8. Well Name and No.
Lybrook G30-2307 01H

Encana Oil & Gas (USA) Inc. wishes to submit an updated access road topographic map and standard road details for the Lybrook G30-2307 01H APD previously approved on June 10, 2014. The revisions provide location and design standards for one 150 foot by 20 foot pullout for safe driving conditions during operations. The pullout will be 100 feet long plus 25 feet on each end for transitioning, with 10 feet in width for driving area and 10 feet for slope and drainage (see standard details).

LYBROOK G30-2307
1331' FNL & 2114' FEL
LOCATED IN THE SW/4 NE/4 OF SECTION 30
T23N, R07W, N.M.P.M.
SANDOVAL COUNTY, NEW MEXICO

SAN JUAN ROAD DETAILS
TYPICAL ROAD SECTIONS AND TURNOUT DETAILS

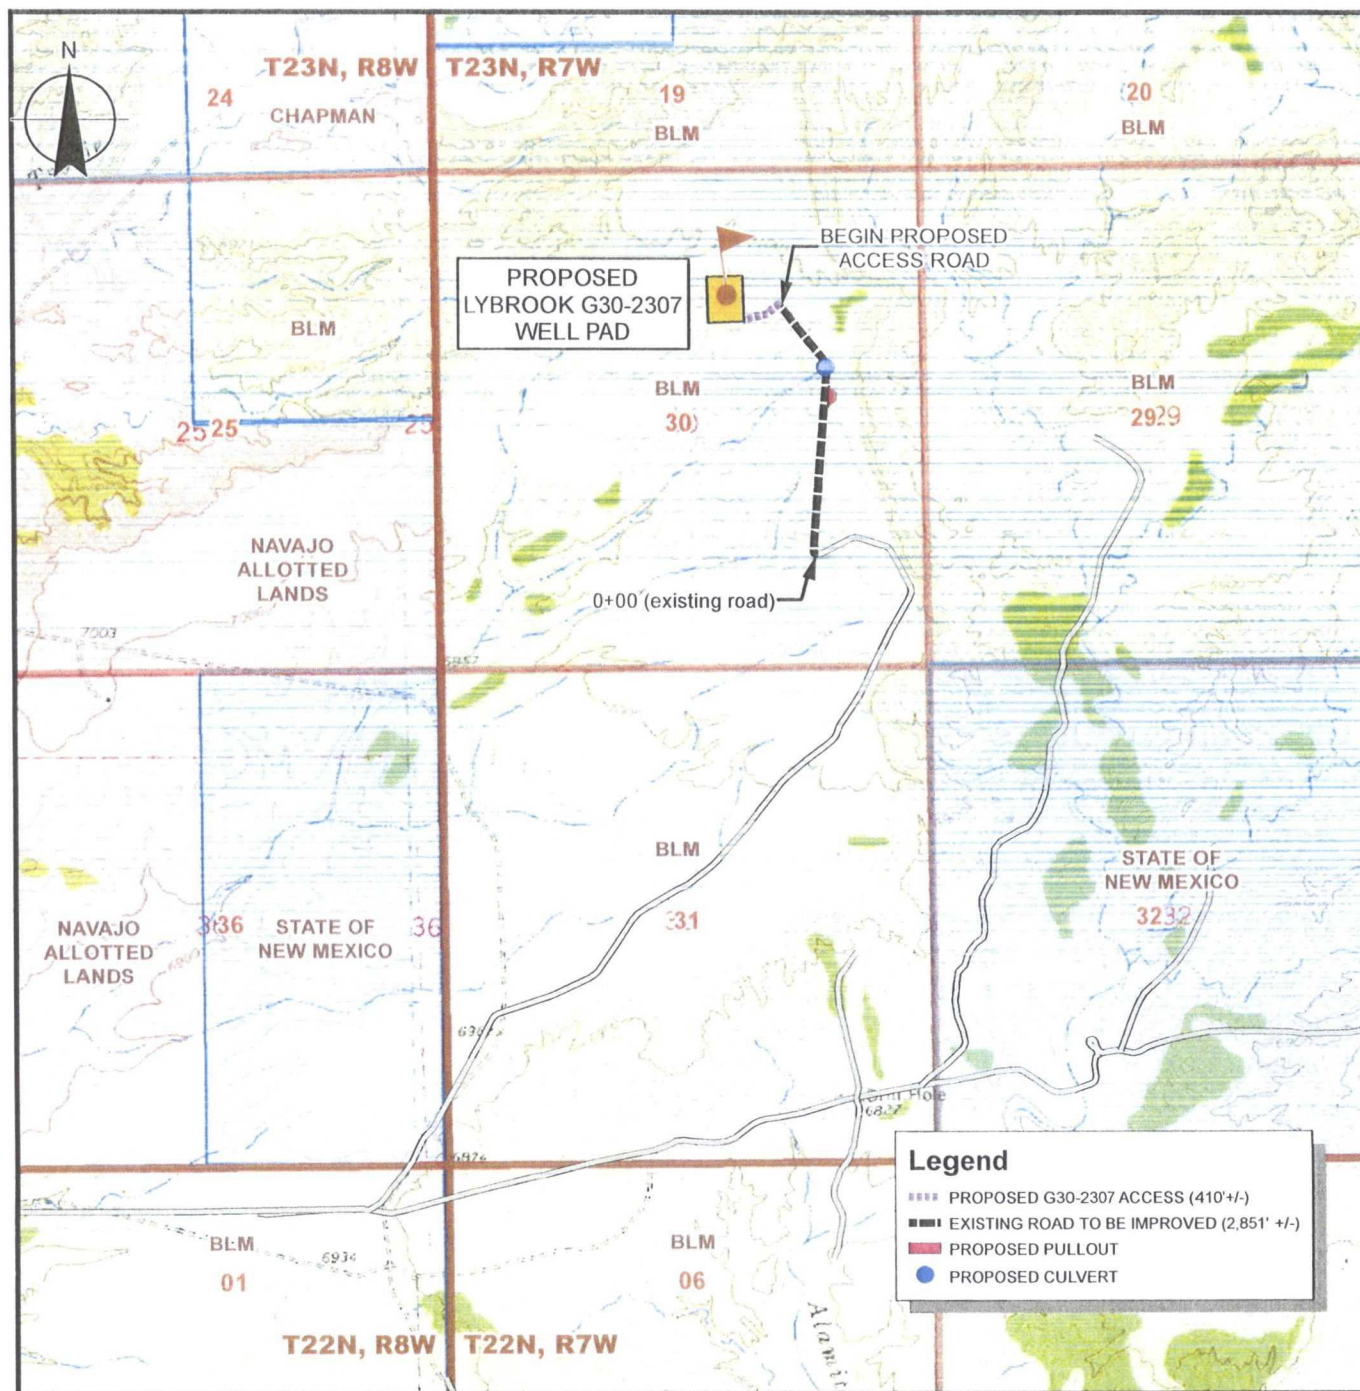
16+61 Begin Pullout (Right)
18+11 End Pullout (Right)
20+34 Install Culvert
28+51 Begin New Access
32+61 Road at Pad
